WMWD Conditions of Approval for Proposed Project

CONDITIONS OF APPROVAL FOR MARB D-1 AVIATION

TECHNICAL MEMORANDUM

To: Karl Francis & Ginger Han, Western Municipal Water District
From: Elizabeth Caliva & Jenny Li, Dudek
Subject: Fire Flow Hydraulic Modeling for the D-1 Development on MARB
Date: April 11, 2023
Attachments: A – Utility Plan – Option 4
B – Detailed Cost Estimate for Pipeline Upsizing

Figure 5: Minimum Junction Pressures and Maximum Pipeline Velocities – Existing MDD + FF Analysis – Detail

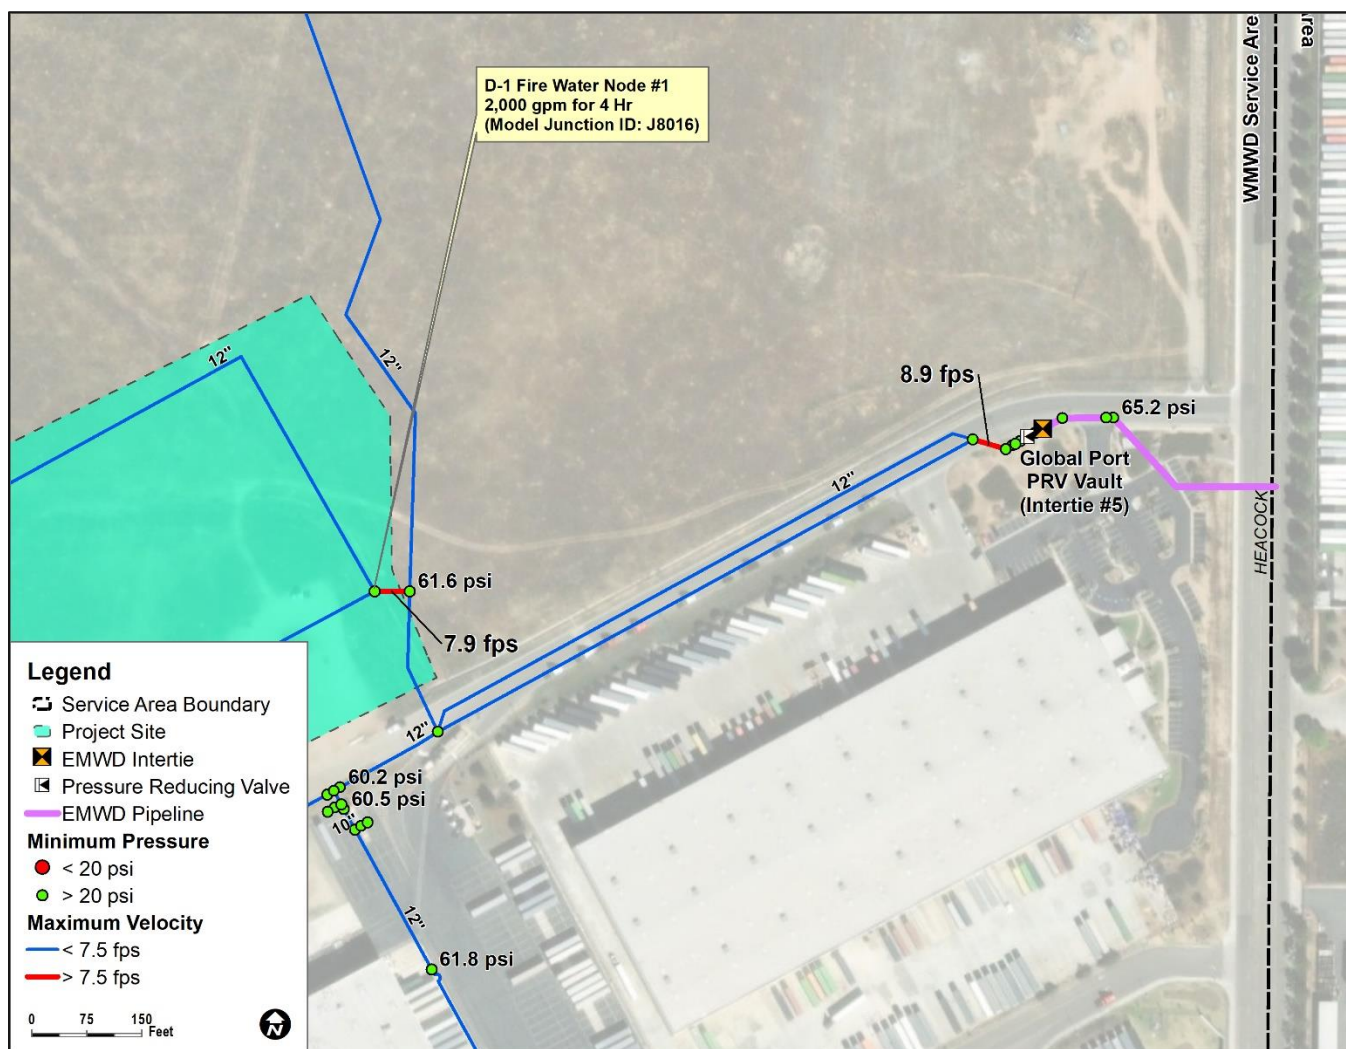
Velocities for most pipelines are not expected to exceed 7.5 fps. However, as detailed in **Figure 5**, two short sections of pipe are anticipated to exceed 7.5 fps. These include the 12-inch fire loop connection (approximately 50-LF) to the relocated 12-inch waterline on the east side of the building, which is anticipated to have a maximum pipeline velocity of 7.9 fps and approximately 50-LF of 12-inch pipeline between the dual 12-inch within the access road and the Global Port PRV, which is anticipated to reach a maximum velocity of 8.9 fps.

- The as-proposed D-1 development piping plan is anticipated to result in maximum pipeline velocity violations at two locations under existing, near-term, and ultimate maximum day plus fire flow conditions. Approximately 100 LF total of 12-inch pipeline (proposed and existing) is recommended to be upsized to 16-inch to eliminate the high velocity violations at the two locations identified.

Figure 8: Minimum Junction Pressures and Maximum Pipeline Velocities – Near-Term MDD + FF Analysis – Detail

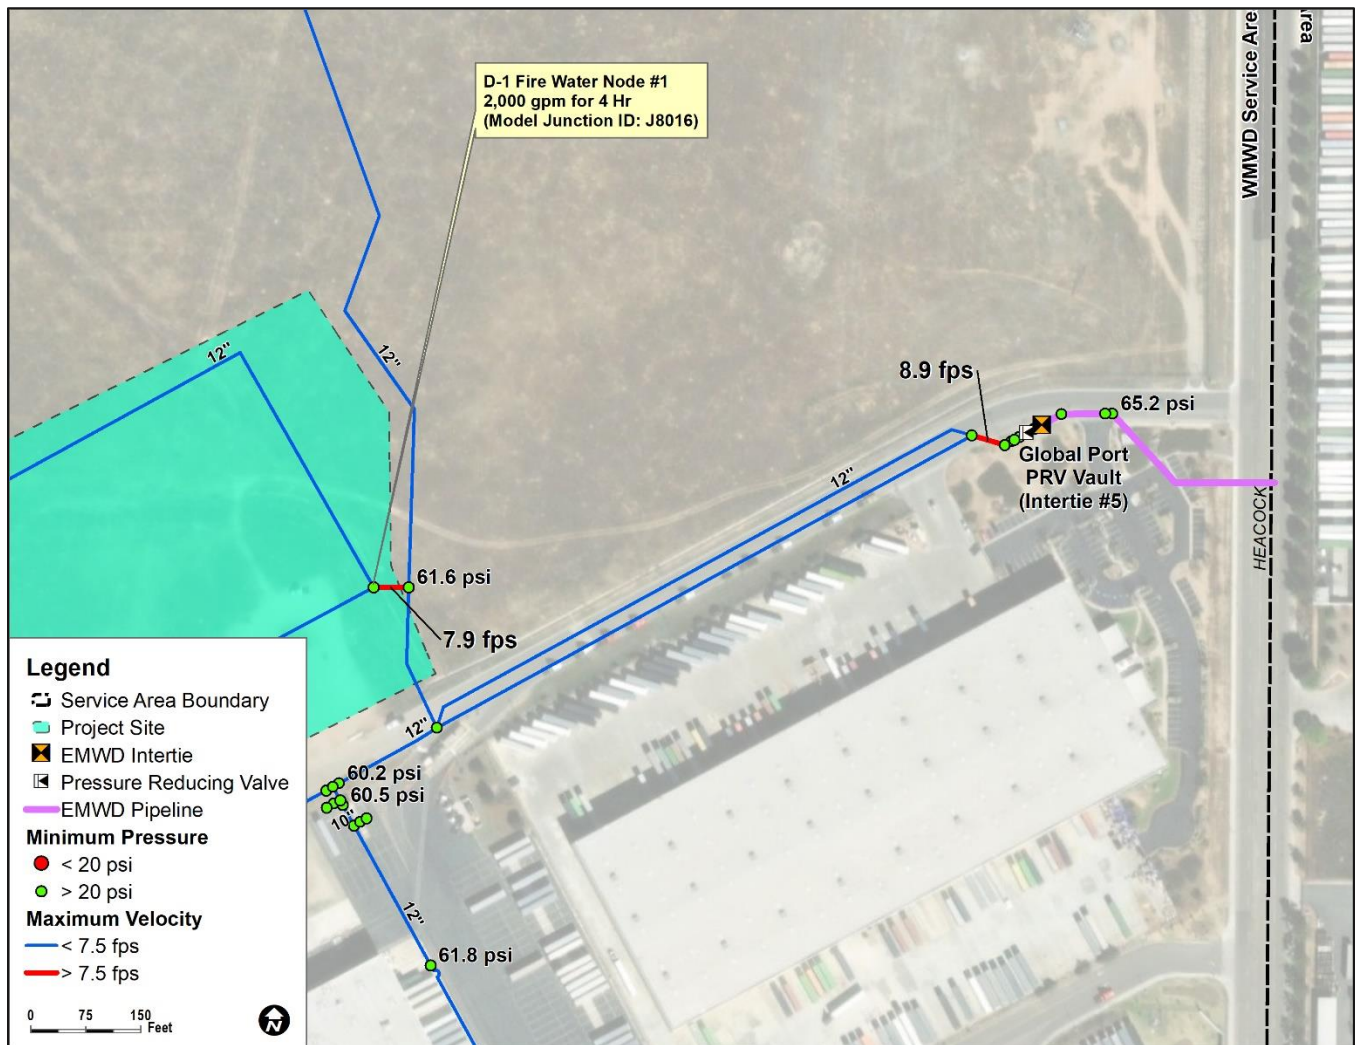
Velocities for most pipelines are not expected to exceed 7.5 fps. However, as shown in **Figure 8**, two short sections of pipe are anticipated to exceed 7.5 fps. These include the 12-inch fire loop connection (approximately 50-LF) to the relocated 12-inch waterline on the east side of the building, which is anticipated to have a maximum pipeline velocity of 7.9 fps and approximately 50 LF of 12-inch pipeline between the dual 12-inch within the access road and the Global Port PRV, which is anticipated to reach a maximum velocity of 8.9 fps.

Figure 11: Minimum Junction Pressures and Maximum Pipeline Velocities – Ultimate MDD + FF Analysis – Detail

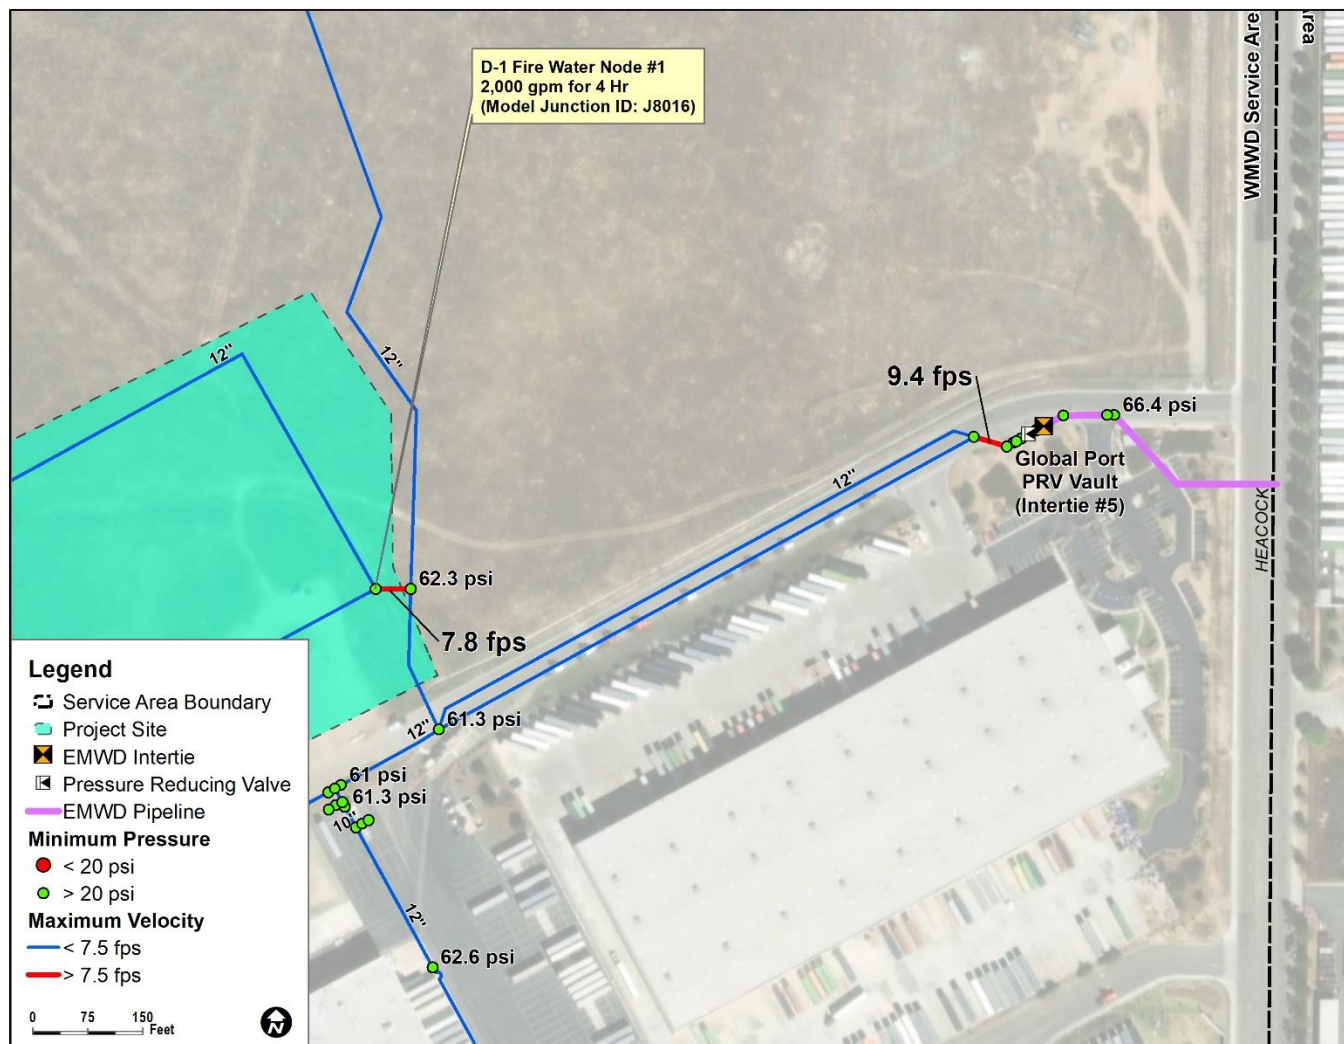
Velocities for most pipelines are not expected to exceed 7.5 fps. However, as shown in **Figure 11**, two short sections of pipe are anticipated to exceed 7.5 fps. These include the 12-inch fire loop connection (approximately 50-LF) to the relocated 12-inch waterline on the east side of the building, which is anticipated to have a maximum pipeline velocity of 7.8 fps and approximately 50 LF of 12-inch pipeline between the dual 12-inch within the access road and the Global Port PRV, which is anticipated to reach a maximum velocity of 9.4 fps.

Figure 12: Minimum Junction Pressures and Maximum Pipeline Velocities – Ultimate MDD + FF Analysis with Recommended Pipeline Upsizing

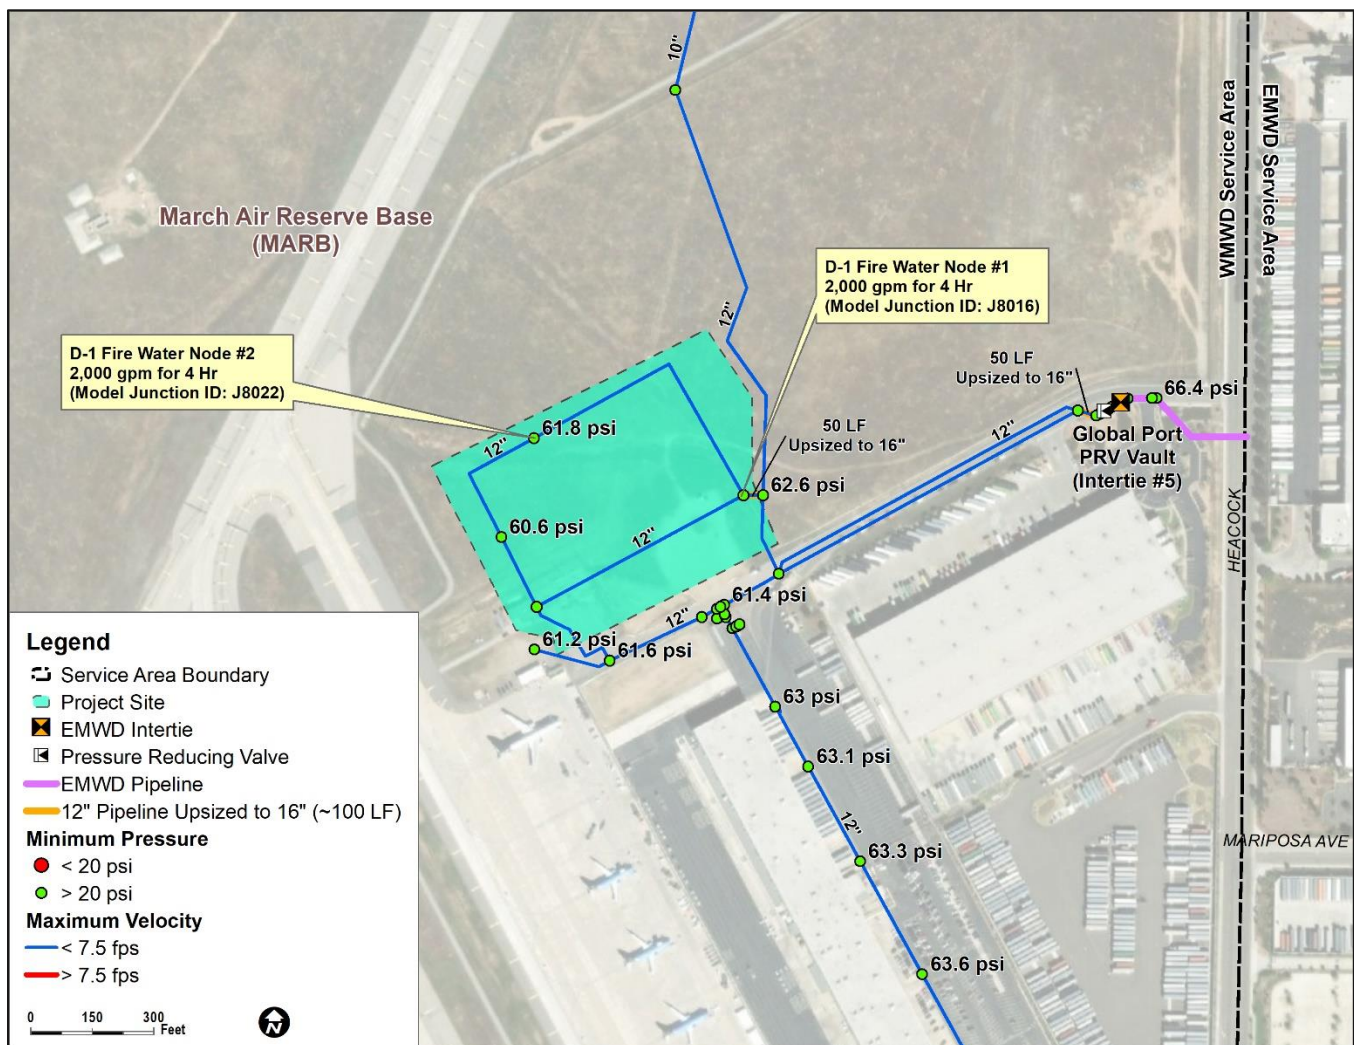
The two short segments of pipeline anticipated to exceed the District's maximum velocity criterion of 7.5 fps under existing, near-term, and ultimate MDD plus fire flow conditions were upsized from 12-inch to 16-inch in the ultimate system analysis. The results shown in **Figure 12** indicate that under ultimate MDD plus fire flow conditions and with approximately 100 LF of 12-inch pipeline upsized to 16-inch, residual pressures are anticipated to remain above 20 psi and maximum velocities not to exceed 7.5 fps throughout the District's facilities in the vicinity of the proposed development. The maximum pipeline velocity is anticipated to be 5.3 fps in the short new segment of upsized 16-inch pipeline serving the Global Port PRV vault.

- According to Western, the parallel 12-inch pipe as proposed in the D-1 Development drawings provided for this project is unacceptable. The District requires the full replacement of the existing 12-inch pipeline (approximately 830 LF) with a 16-inch pipeline.
